NOTE TO: J. Chambers, GE
FROM: Chet Poslusny, NRR, NRC
SUBJECT: PRELIMINARY STAFF FEEDBACK ON ITAAC PHASE 3

COMMENTS ON
ABWR TIER 1 DESIGN DOCUMENTATION
PHASE 3 SUBMITTAL

Figure 2.3.1 Location of Process Radiation Monitors

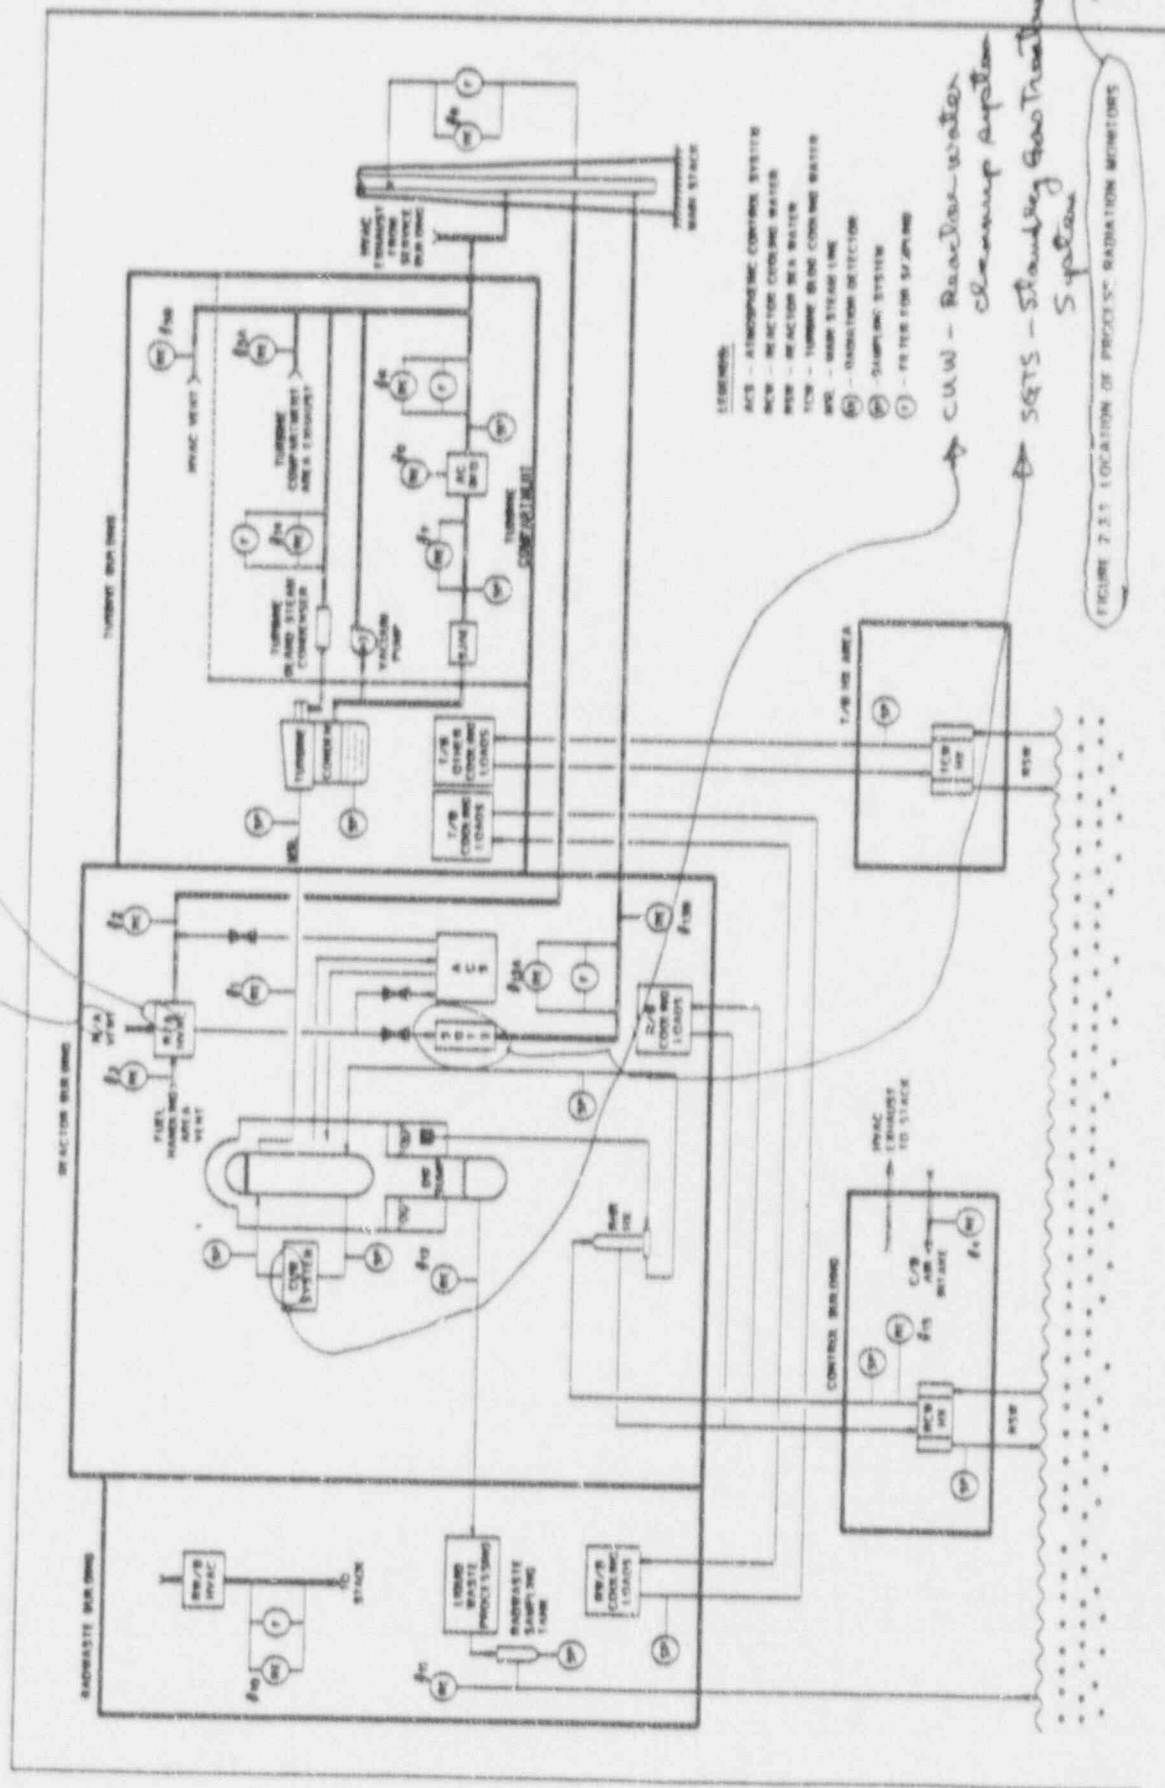
Location of the process radiation monitors is shown in the plant layout drawing of Figure 2.3.1. The radiation detectors are numbered according to the listing provided above.

Figure 2.10.22 Off-Gas System

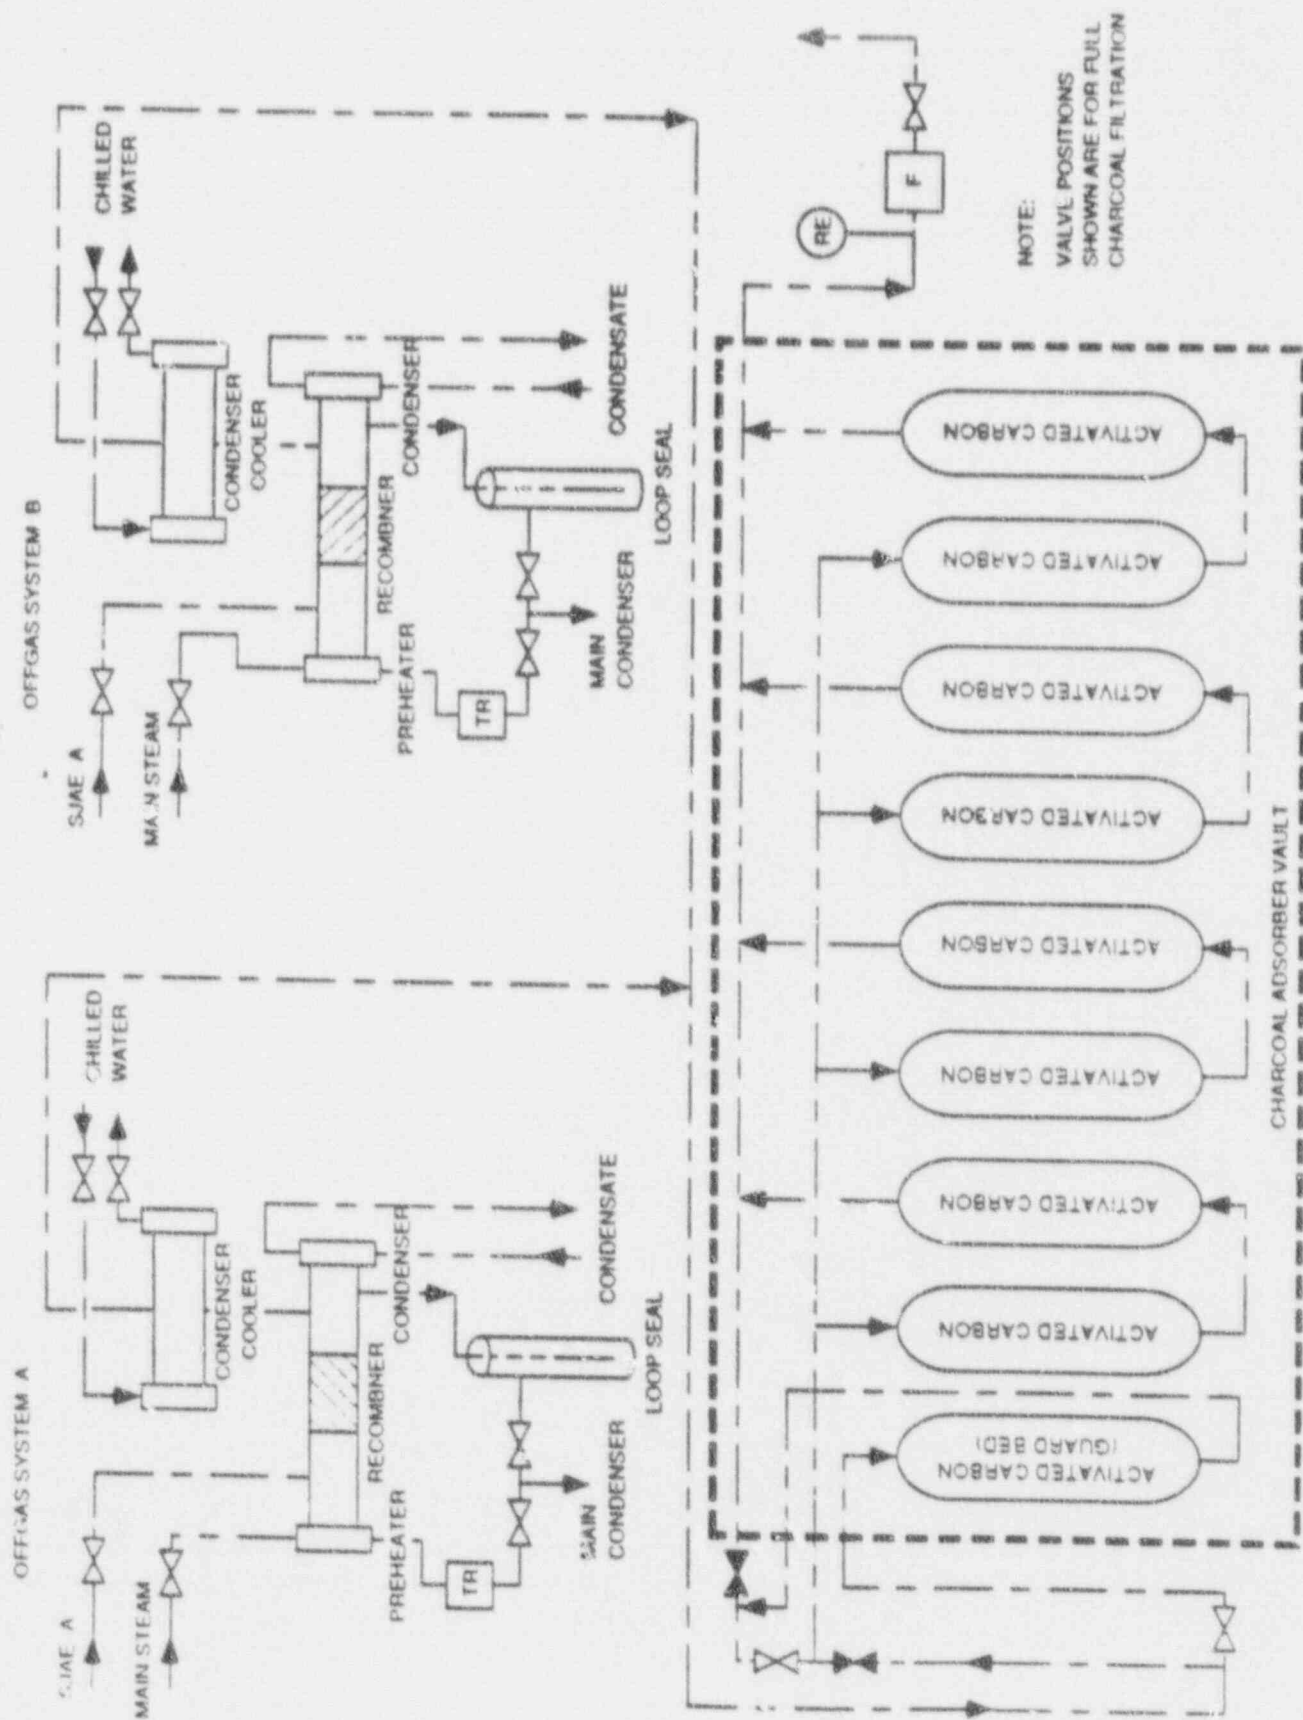
4.2 On Figure 2.10.3, "Off-Gas System", show (1) redundant hydrogen analyzers, (2) temperature elements in charcoal adsorber vessels, and (3) nitrogen connections for purging and blanketing.

Figure 2.14.1 Primary Containment System

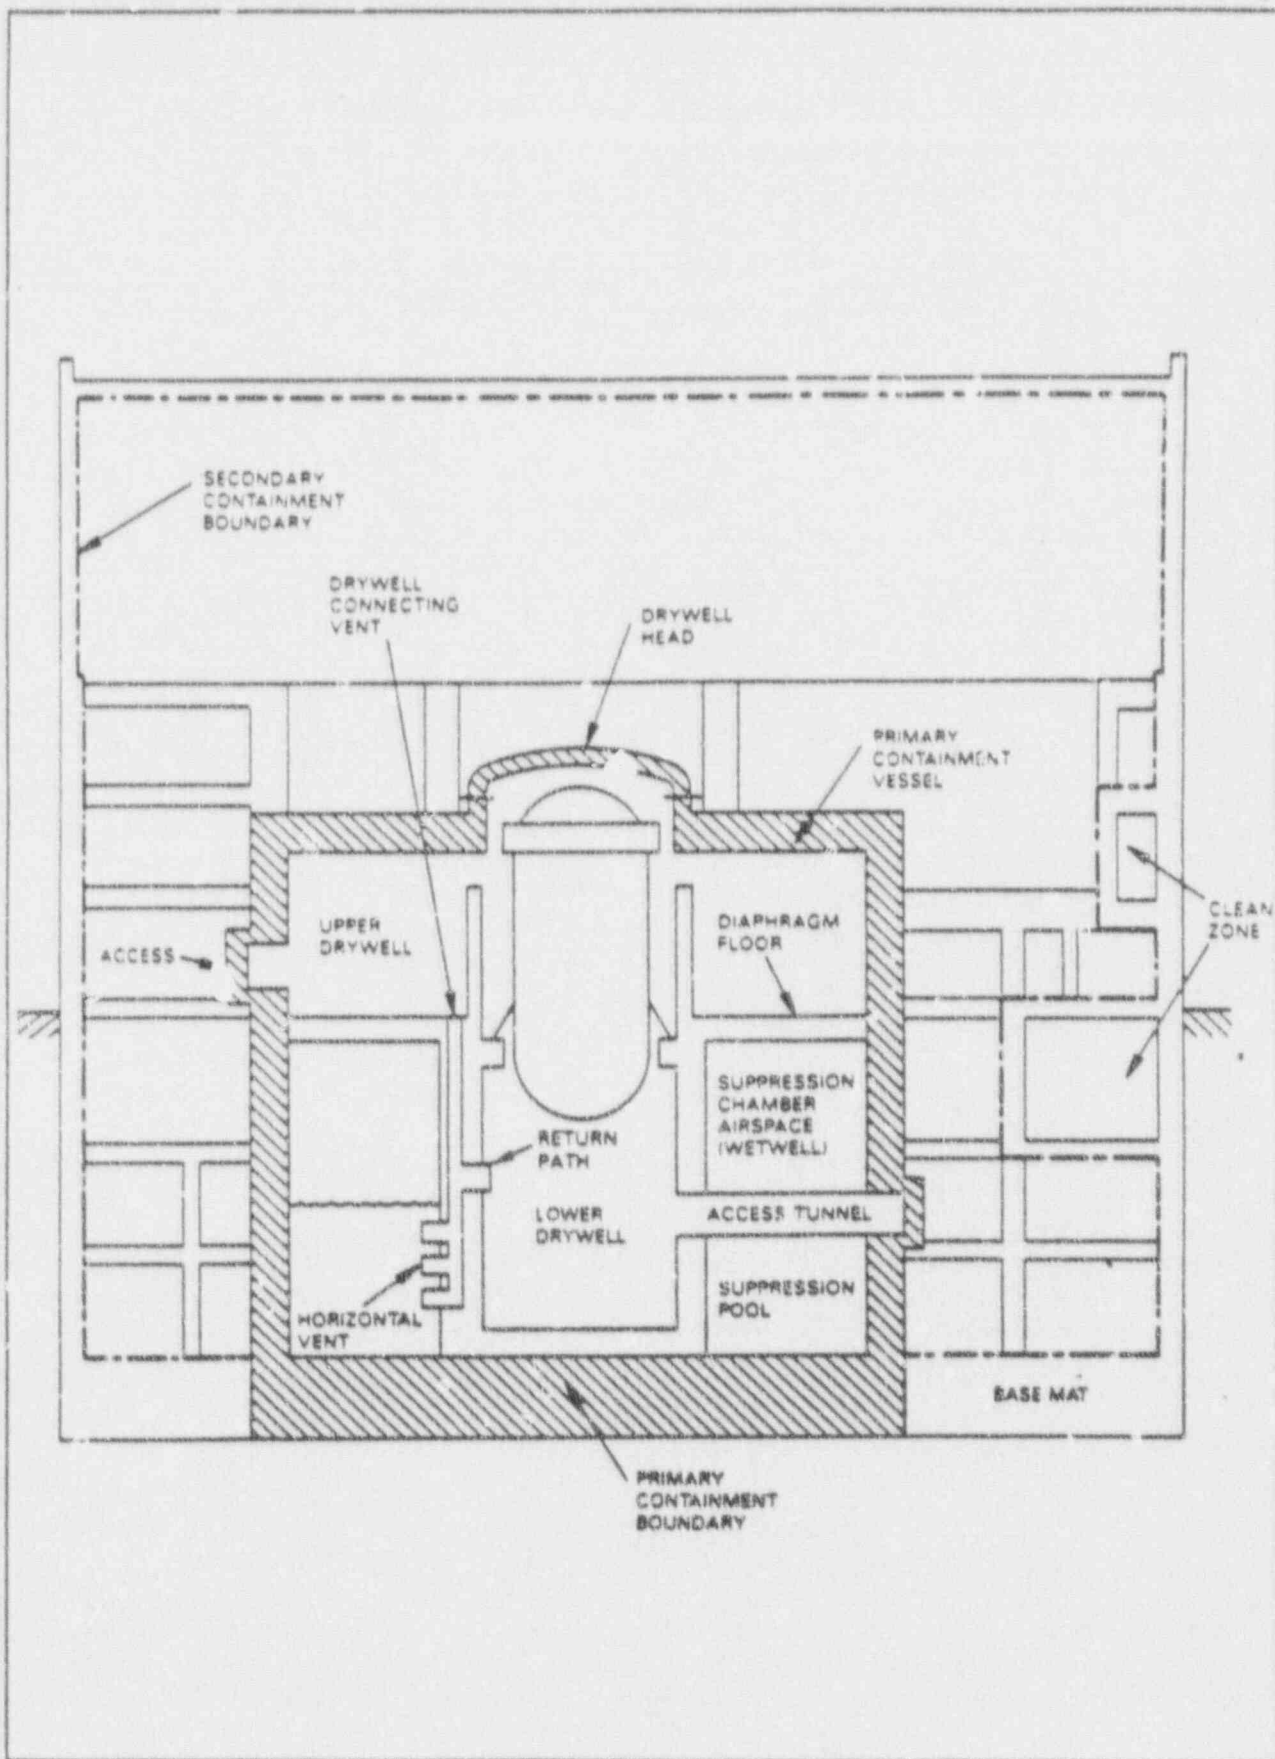
5.1 Add design criteria for bypass leakage between the drywell and the wetwell during and following a LOCA as an ITTAC item in Table 2.14.1 (check with SPLB/NRR).

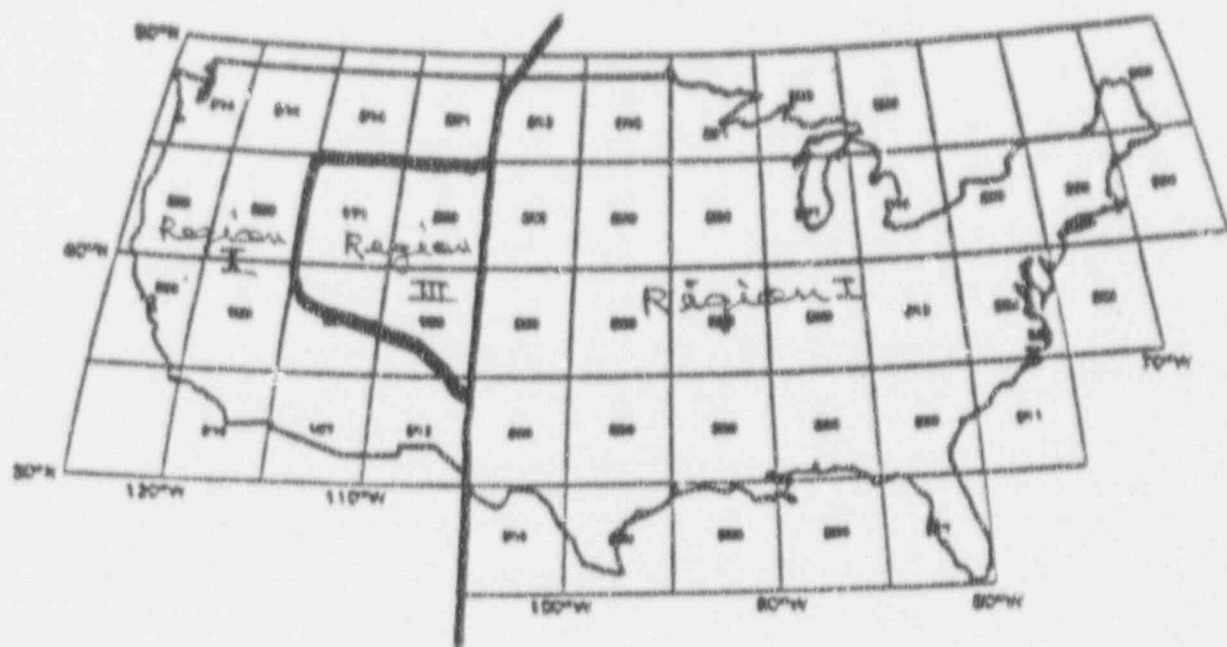
- 8.1 The tornado design basis parameters in Table 5.0 should be revised to the parameters accepted by the staff and agreed by GE. The revised parameters are noted on the enclosed marked-up pages.
- 8.2 A map of the contiguous United States showing the tornado design regions (I, II, and III) is enclosed.
